Summary Overview of Work to be Performed

- **EV PDI** – Follow attached **WAR305 Pre-Delivery Inspection (PDI) Form: Freightliner – Electric Vehicles**
- Be sure to close out any open safety recalls. In addition, DTNA recommends performing the following work, to close out open service campaigns and service bulletins Complete all Open Campaigns and Recalls.
 - ***SF694 Ground Strap Modification <<<< Once it is published
 - ***SF708 Cooling system replace <<<< Once it is published
- Make sure TSB's and axle oil level have been addressed
 - TSB 20-089 Adjusting the Coolant Pipe Position
 - TSB 35-040 Fixing eAxle Oil Seepage at the Shift to Neutral Tool - Plug Location
- Perform other checks as noted in this document and repair as necessary.
 - Report back to Travis Ingram any other issues found while doing these tasks.

Fig. 1, Location of the Low Voltage Batteries

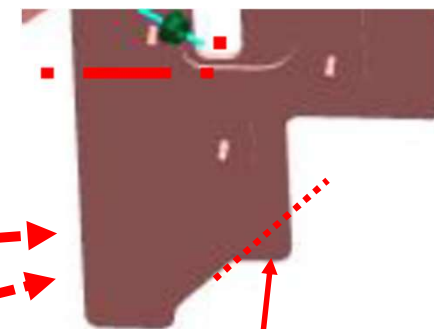
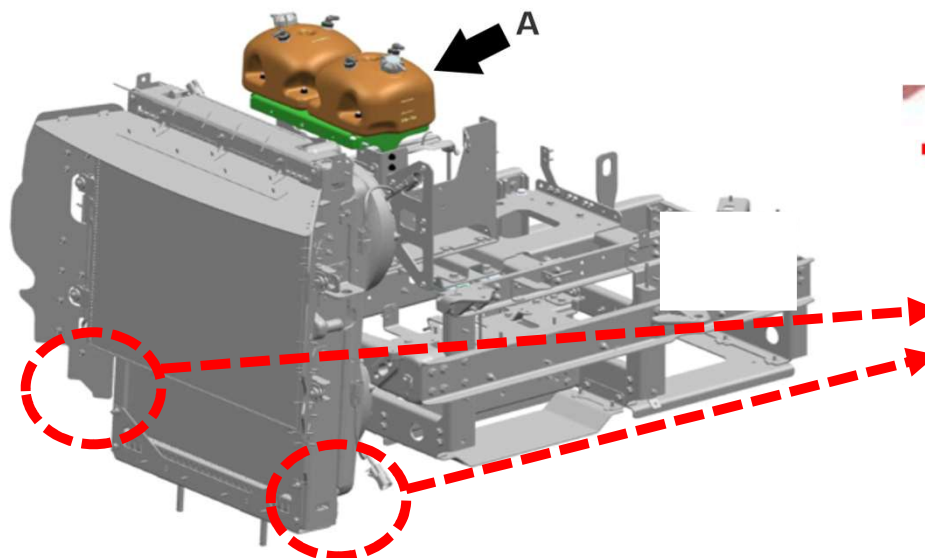
- Mod 4NJ, Section of 13.7 of the eCascadia Workshop: Inspect the Low Voltage (LV) Battery. If not factory battery, replace with DTNA spec'd battery and make sure hold downs are in place.
 - Spec'd Battery is **A66-06013-002** >>> Replaced by **ODX AGM31** which shows PDC inventory
- Mod 290: Make sure Battery Hold down bolts are still installed.

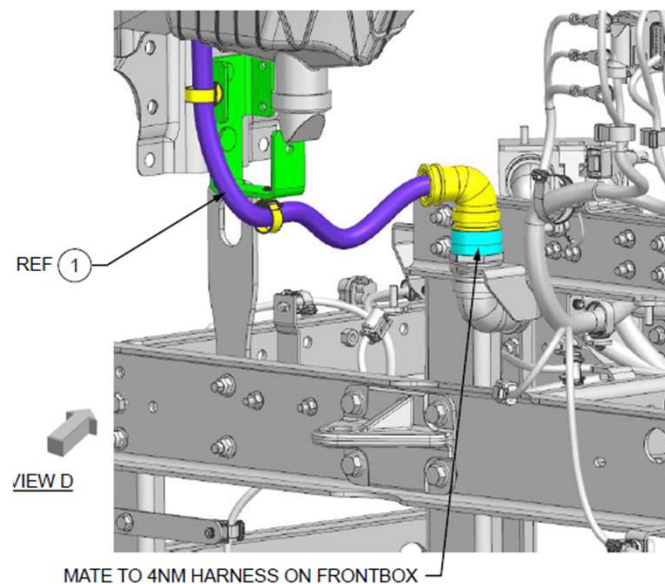
- Mod 278: Trim LH and RH Baffle on bottom of Fan Shroud to prevent it from rubbing on harness that routes around lower radiator

Continue existing
angled cut to edge
and remove corner

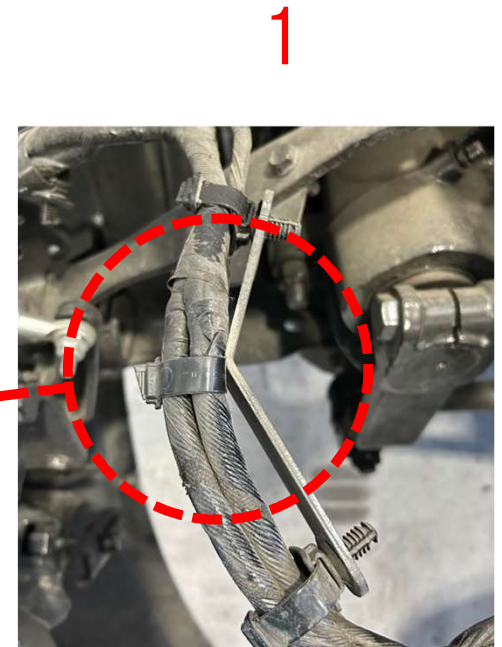
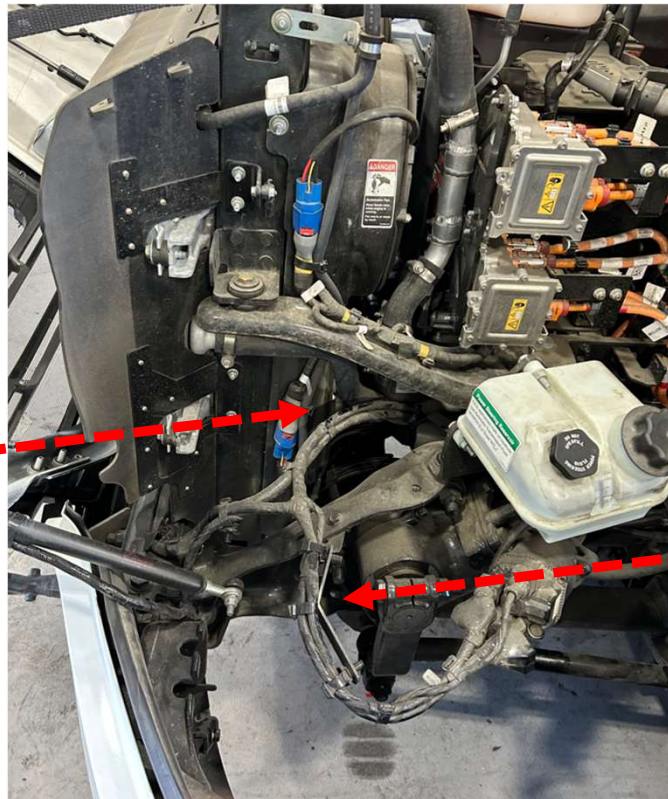
- Mod 321: Passenger side Firewall: Make sure there is a drip loop in harness going from firewall to Deutsch Connector

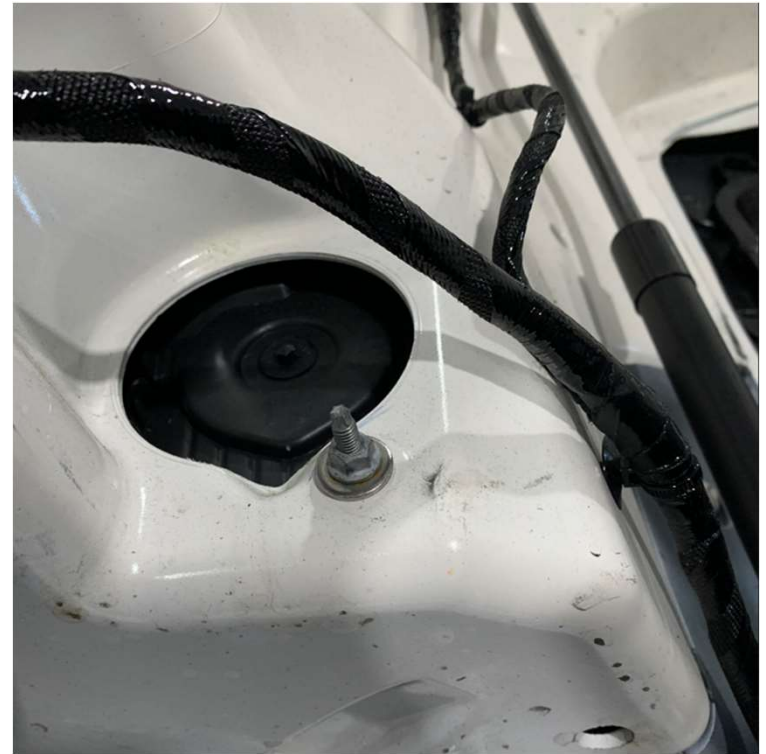
- Mod 475/288: 1) Add some slack to make sure power steering harness cannot rub on bracket by steering gear
2) Make sure harness is not rubbing on 3/2 coolant valve

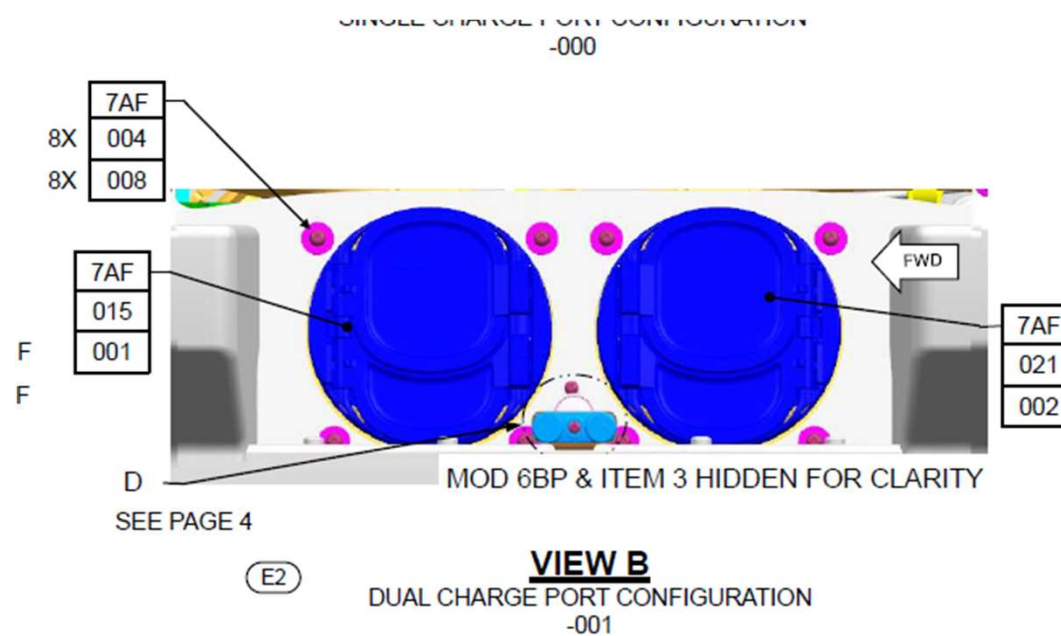
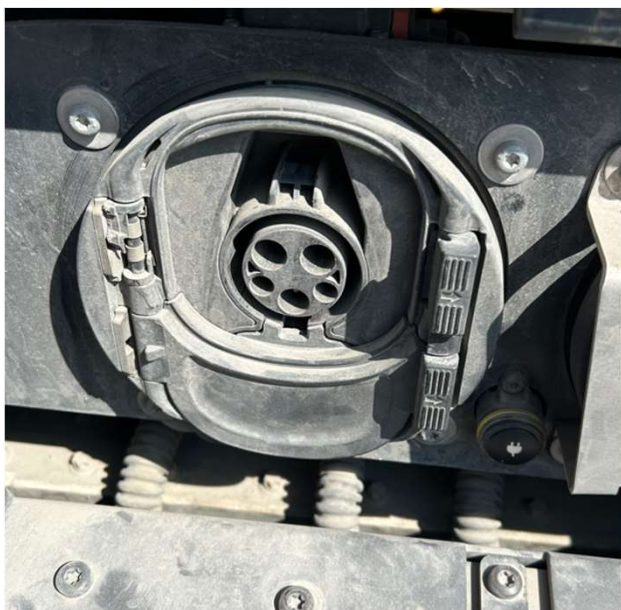
- Mod 475: Check for headlamp bolts rubbing on harness when hood is closed. Bracket can be bent so bolt doesn't hit harness or bracket.

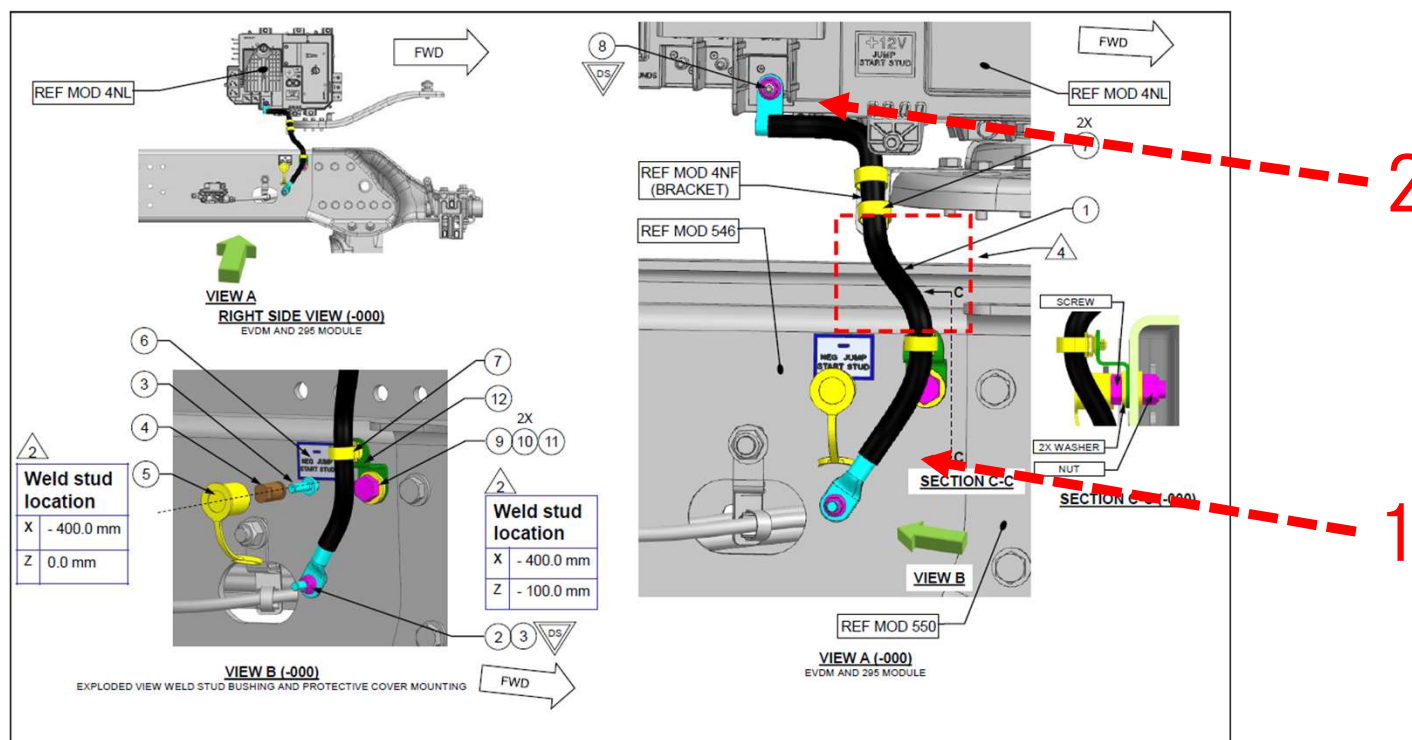
- Mod 7AF - Make sure charge port cover is not broken and lock function correctly

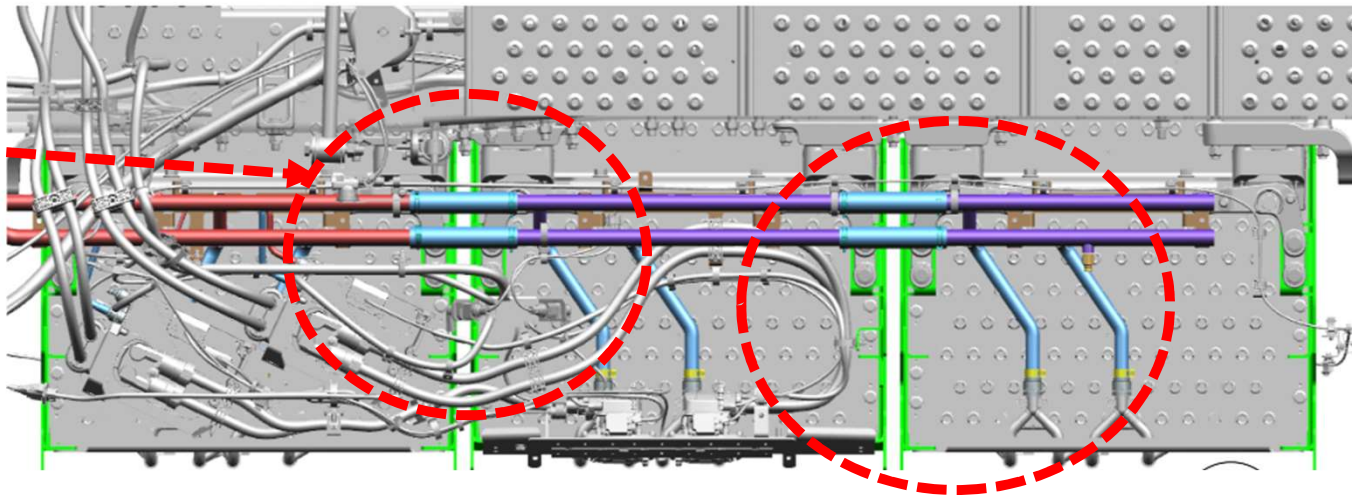
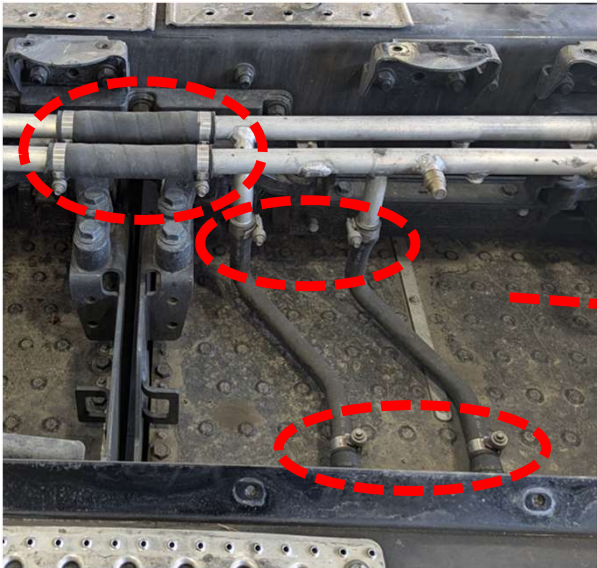
- Mod 295 –
 - 1) Relocate Frame Ground lower on rail (this will be SF694 Campaign when published)
 - 2) Make sure nut it tight at EVDM end.

EAPU

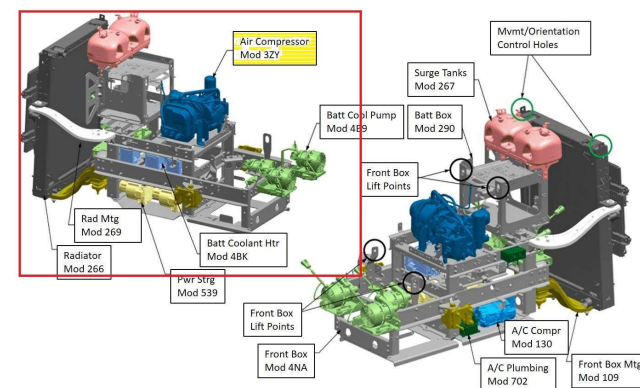
- Mod 3ZY (Compressor) & Mod 38S (EAPU) – Check for signs of oil under EDAC. Check air filter on EAPU if oil seen.

- Change Desiccant Cartridge in EAPU.
 - Reference eCascadia Maintenance Manual **section 11.5.**
- Check Air Filter on Air Compressor and change if needed.
 - Reference eCascadia Maintenance Manual **section 4.3.**
